# CITY OF SUFFOLK

## ADDENDUM NO. 2

City of Suffolk  
IFB #21024-AG  
October 14, 2020

### Suffolk Pump Station No. 24 Replacement

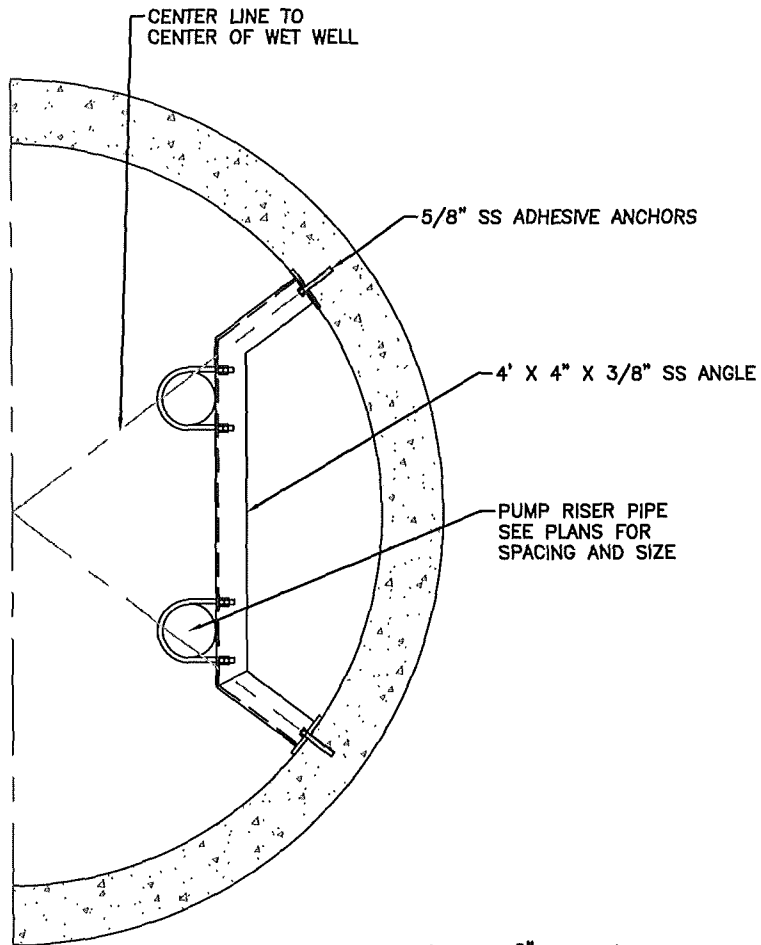
4. **CONTRACTOR QUESTION:** Drawing M1, Section A: Can you provide a detail for the wall mounted pipe supports used in the wet well?

**ADD** the "WET WELL RISER PIPE SUPPORT BRACKET" detail to Sheet M2.

**ENGINEER'S RESPONSE:** See the attached detail.

BASE PLATE

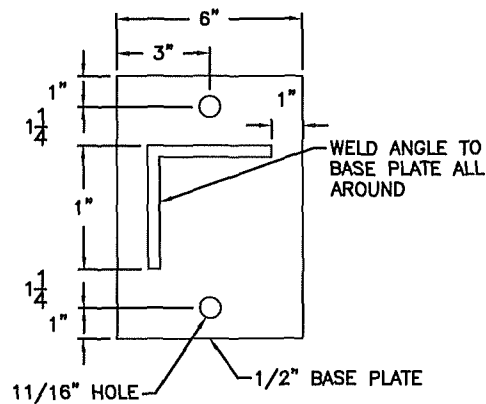
1. U-BOLT TO GO THROUGH INTERMEDIATE SUPPORT AND ANGLE IRON WITH DOUBLE NUTS
2. ALL SUPPORTING HARDWARE SHALL BE STAINLESS STEEL
